FINAL PRODUCT/PROCESS CHANGE NOTIFICATION #20273Generic Copy

Issue Date: 31-Oct-2013**TITLE:** Final PCN for the change of the components in HIC**PROPOSED FIRST SHIP DATE:** 31-Jan-2014**AFFECTED CHANGE CATEGORY(S):** The components for HIC**FOR ANY QUESTIONS CONCERNING THIS NOTIFICATION:**Contact your local ON Semiconductor Sales Office or Ryoichi.Murofushi@onsemi.com**SAMPLES:** Contact your local ON Semiconductor Sales Office or Ryoichi.Murofushi@onsemi.com**ADDITIONAL RELIABILITY DATA:** AvailableContact your local ON Semiconductor Sales Office or Kenichi.Nigo@onsemi.com**NOTIFICATION TYPE:**

STK672-040/050/060A-E

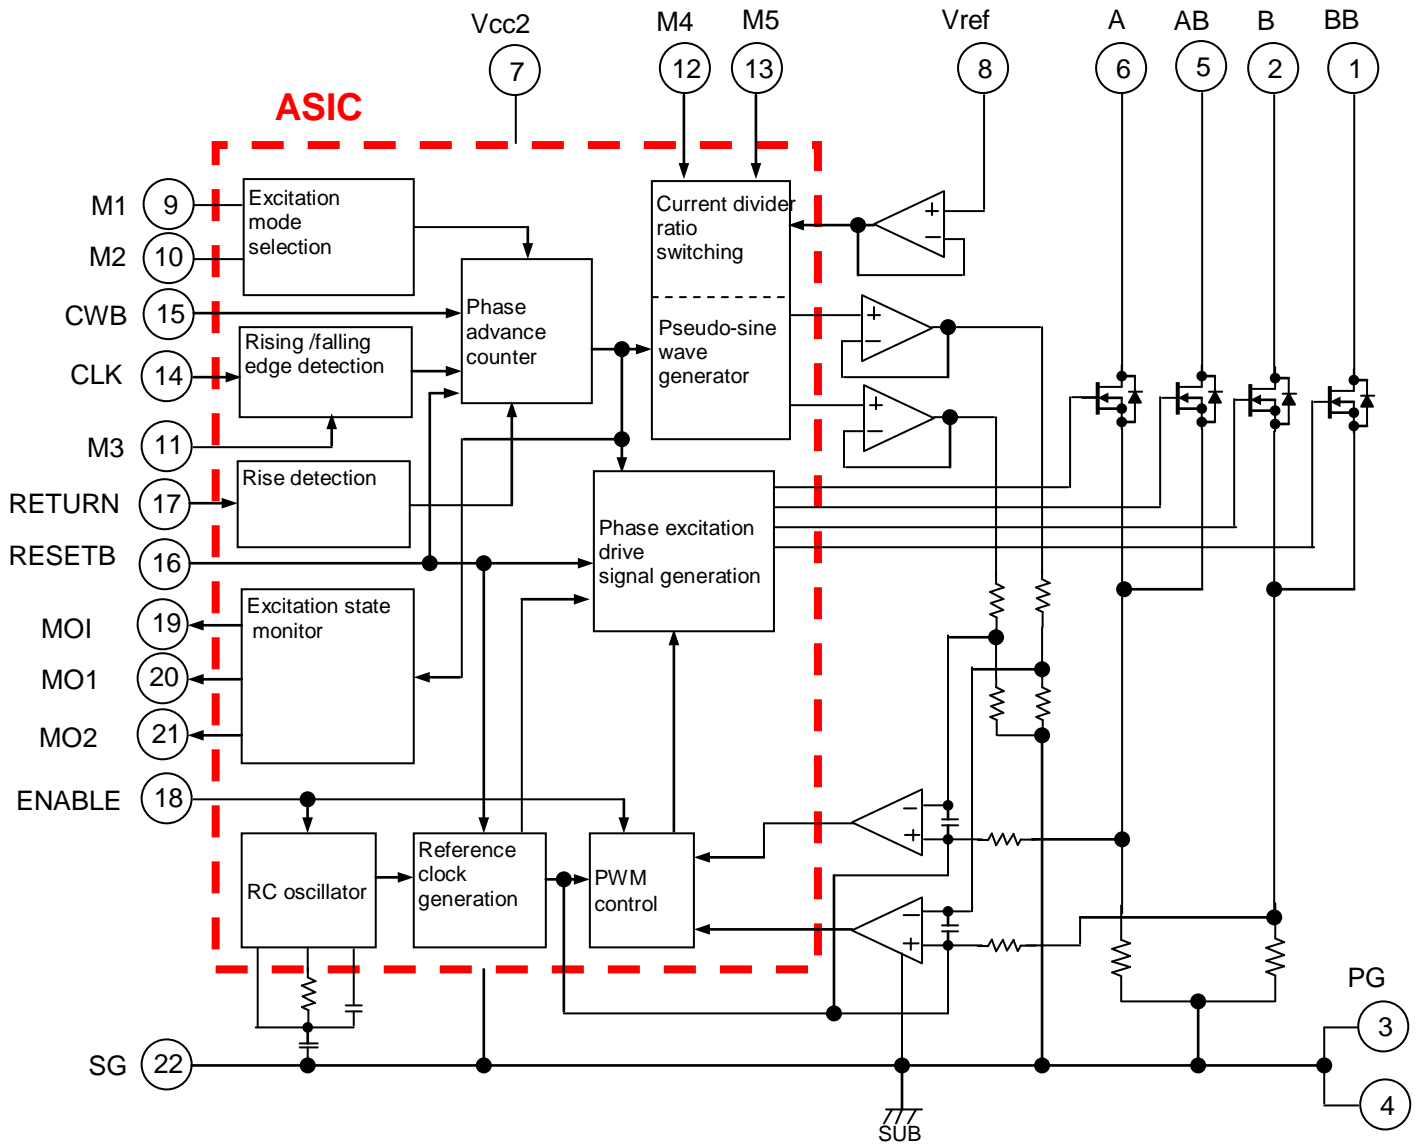
Part in red was changed.

STK672- 070/080/080-SL/081/081-SD-E

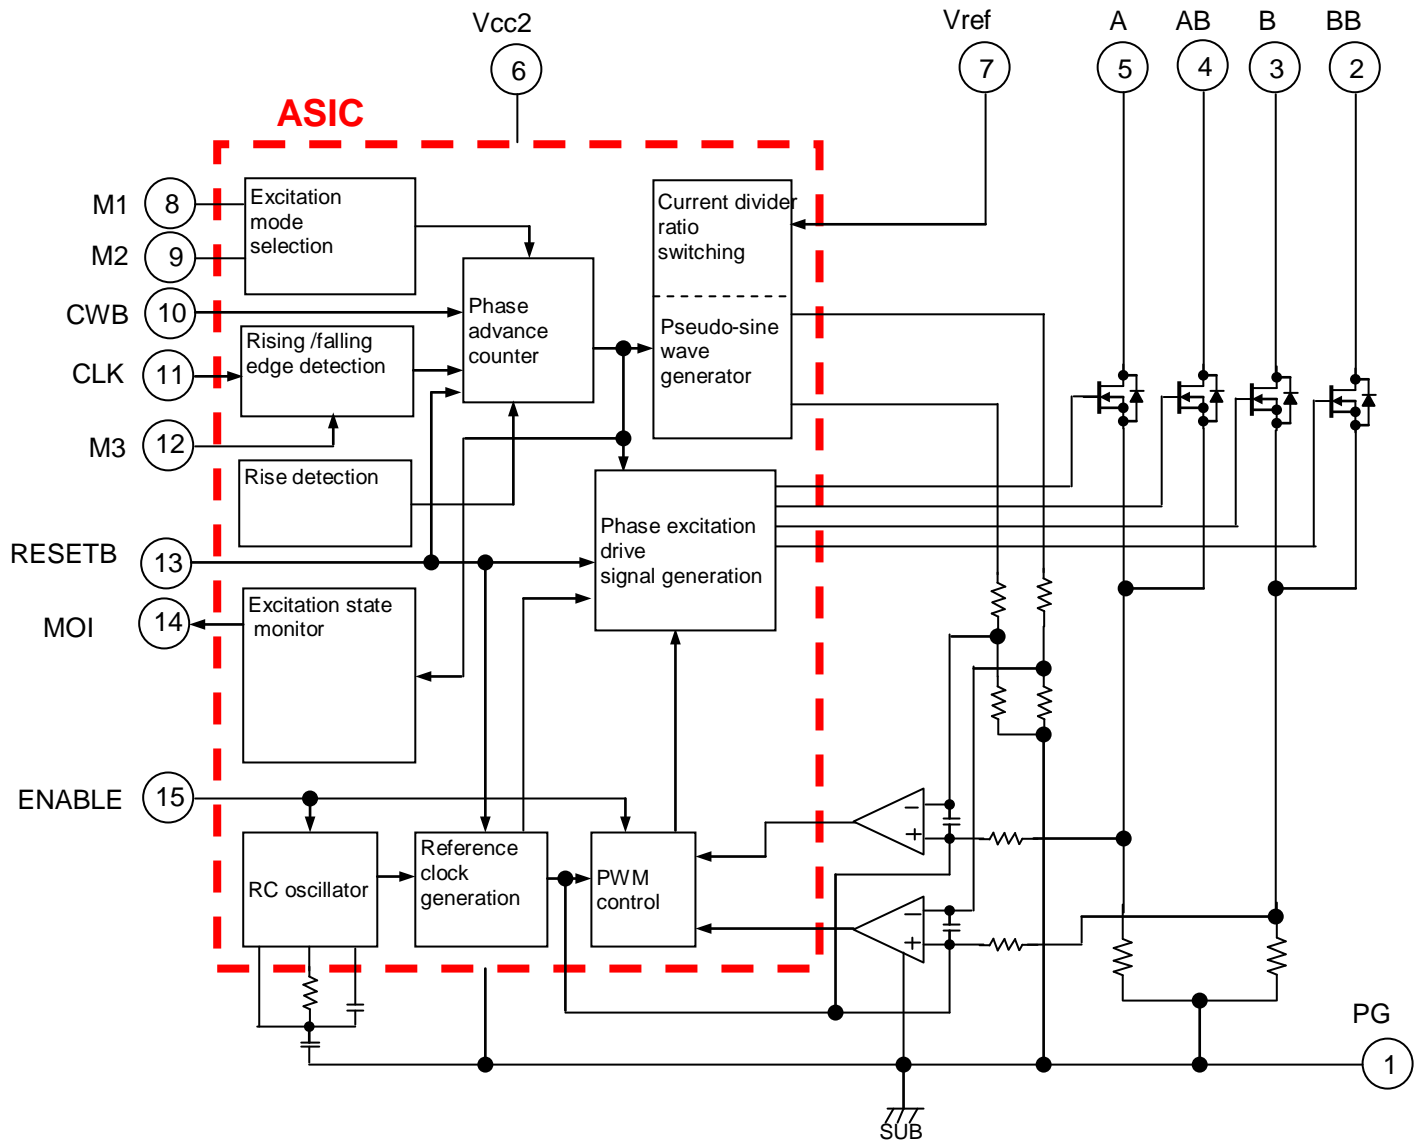
Part in red was changed.
